# Access Compliance Report

## Public Rights-of-Way

### (Curb Ramps)

Intersection ID: 11870	Main Street: CAMP_GREENE_ST	Cross Street: GARIBALDI_AV	Location: SE
ADA ID: FB38AEA37DAB	Ramp Type: Perp	Initial Pass/Fail: Fail	Overall Compliance: No
Codes/Mitigation Info/Possible Solution			Severity Score: 10
			Field Measurements/Component Compliance

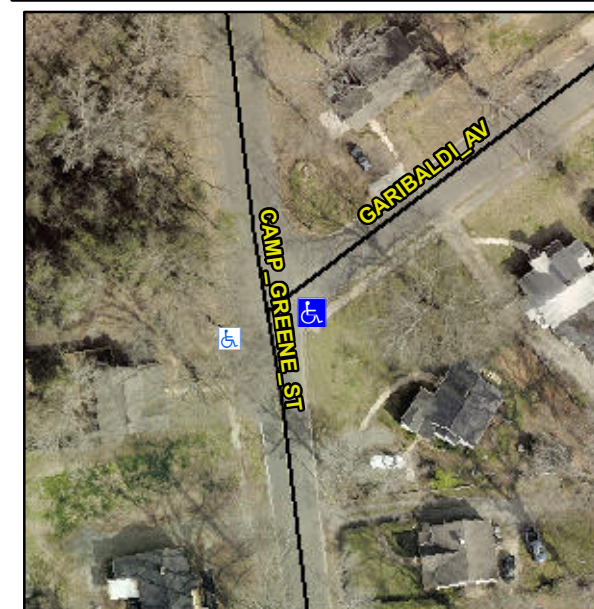
**Not Found, R304.5.1, R304.5.3**

Compliance	Description	Data	Compliance	Description	Data
N/A	Ramp Length (in)	25.0	Yes	Ramp Slope (%)	7.3
No	Ramp Width (in)	47.0	No	Ramp XSlope (%)	3.8
N/A	Flare Type LT	N/A	N/A	Flare Type RT	N/A
N/A	Flare Slope LT (%)	N/A	N/A	Flare Slope RT (%)	N/A
N/A	Flare Traversable LT?	N/A	N/A	Flare Traversable RT?	N/A
N/A	Landing Length (in)	N/A	N/A	DWS Provided?	N/A
N/A	Landing Width (in)	N/A	N/A	DWS Contrast?	N/A
N/A	Landing Slope (%)	N/A	N/A	DWS Length (in)	N/A
N/A	Landing X Slope (%)	N/A	N/A	DWS Full Width?	N/A
N/A	Landing Curb? (Y/N)	N/A	N/A	DWS Offset (in)	N/A
N/A	Shared Landing?	N/A			
N/A	Gutter Ponding?	N/A	N/A	Gutter Slope (%)	N/A
N/A	Gutter Lip Ht (in)	N/A	N/A	Gutter X Slope (%)	N/A
N/A	Painted X Walk1?	No	N/A	Painted X Walk2?	N/A
	X Walk 1 Direction	To W		X Walk 2 Direction	N/A
N/A	X Walk 1 Width (in)	N/A	N/A	X Walk 2 Width (in)	N/A
	X Walk 1 Slope (%)	6.8		X Walk 2 Slope (%)	N/A
	X Walk 1 X Slope (%)	1.5		X Walk 2 X Slope (%)	N/A

**Remove & Replace Entire Ramp.**
